## Avon Parks – Burnett Park and Winton Meadows Park Addendum 02

DATE: Friday, February 20, 2026

PROJECT NAME: **Burnette Park and Winton Meadows Park**

The extent of this addendum is as follows:

**REVISION SCHEDULE**

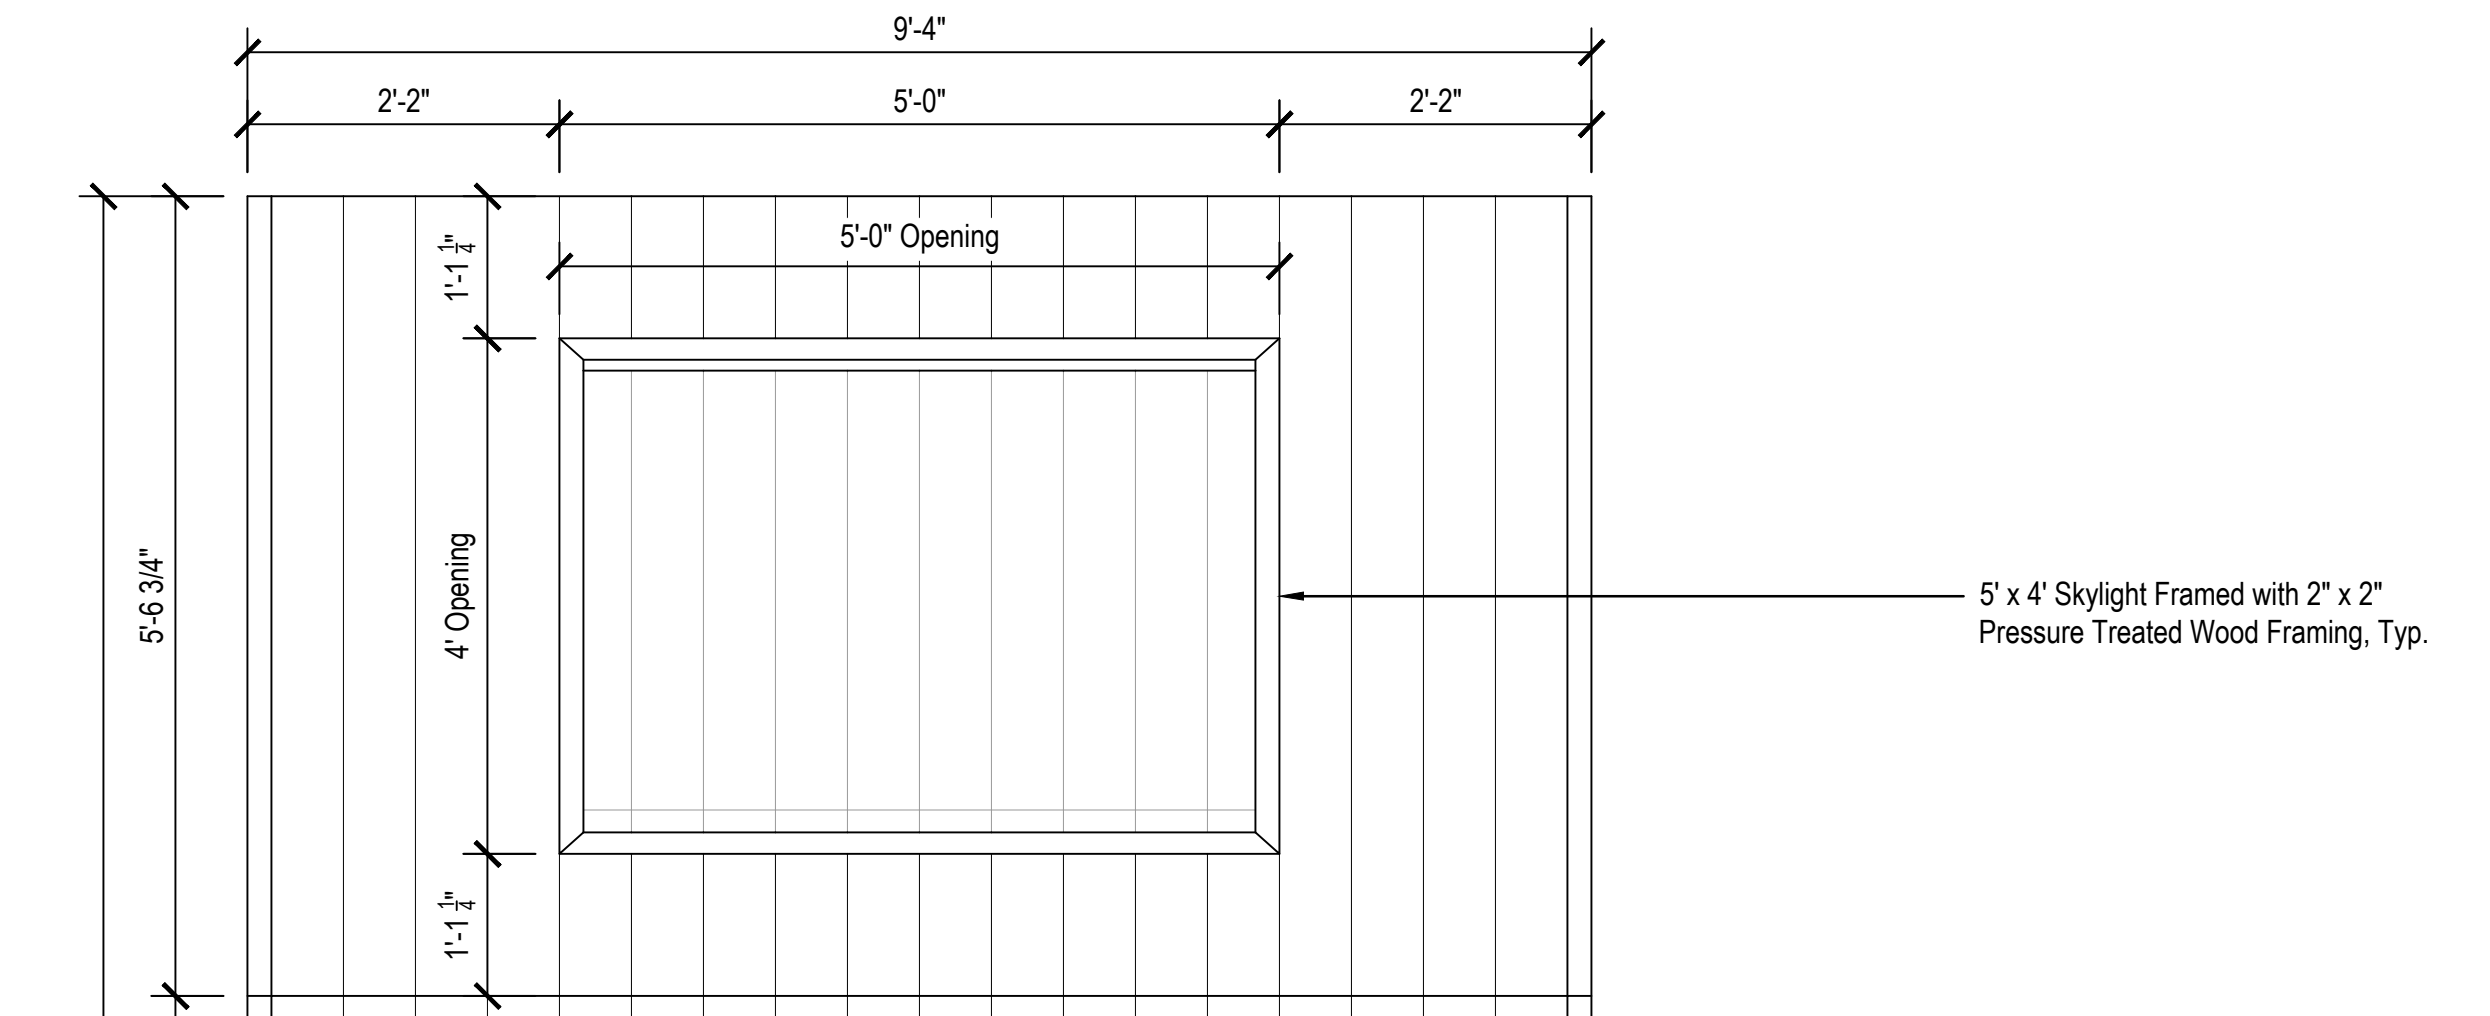
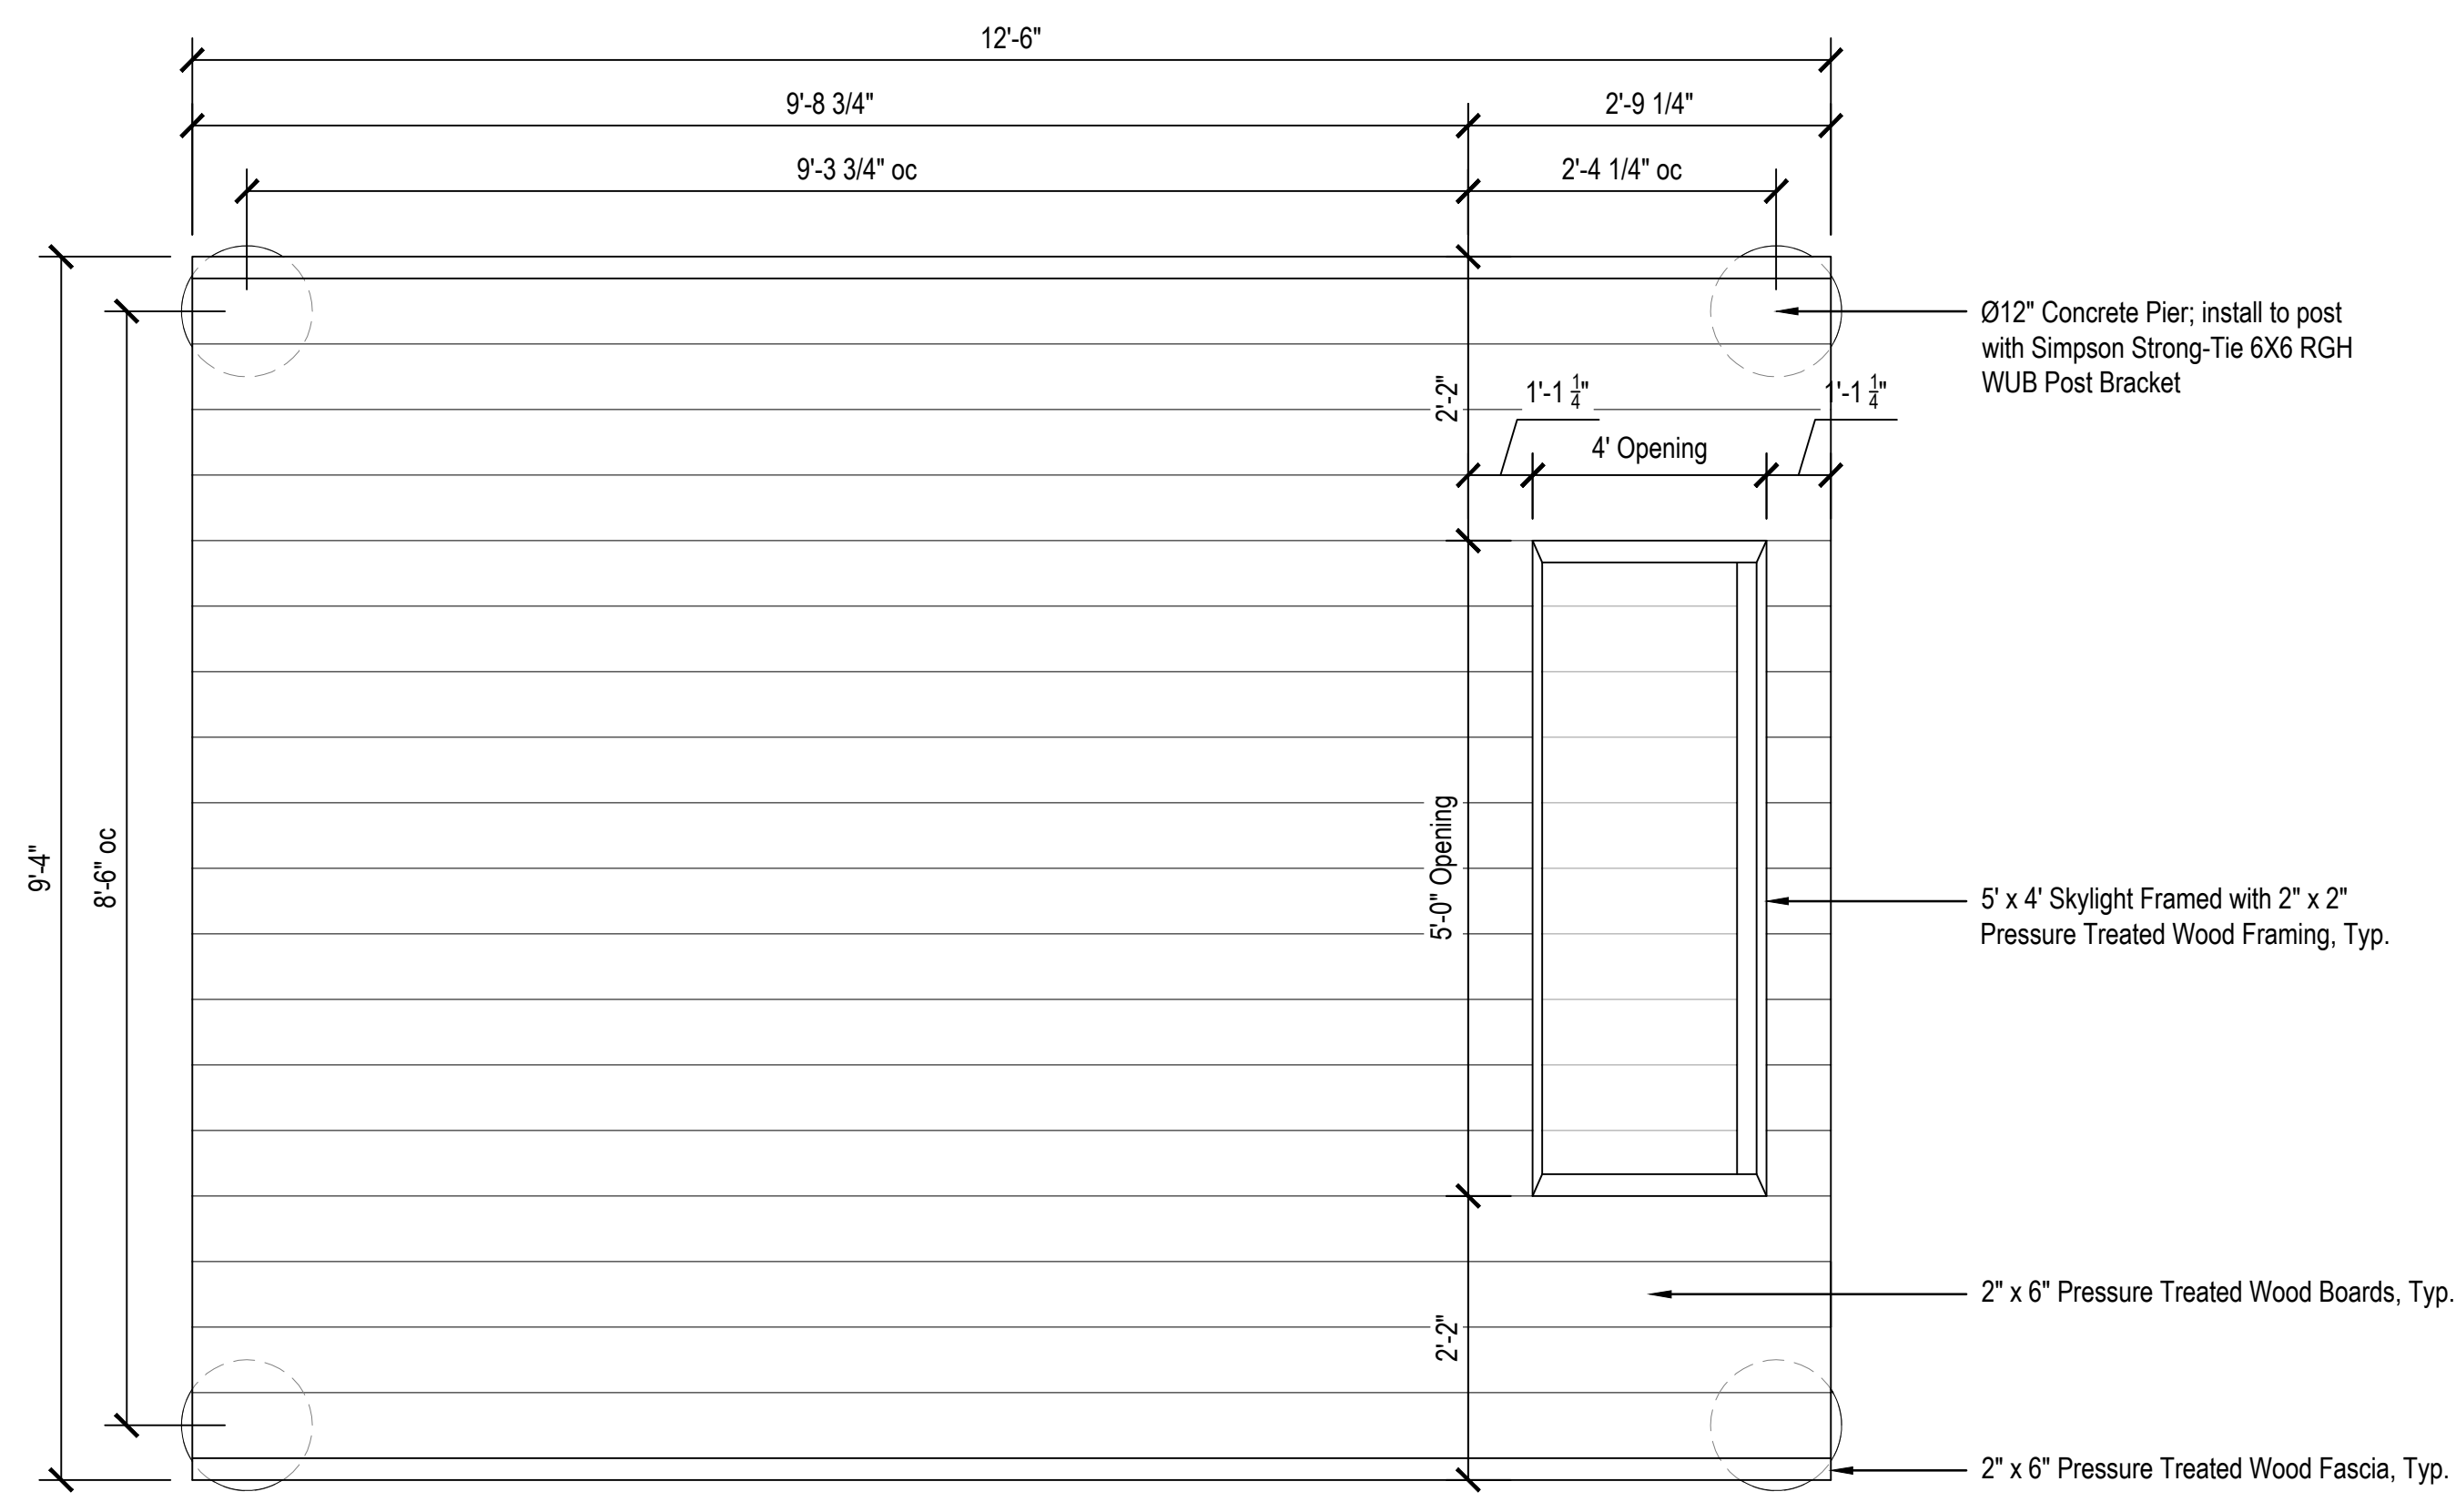
- a) Joists adjusted to be perpendicular to structure floorboards.
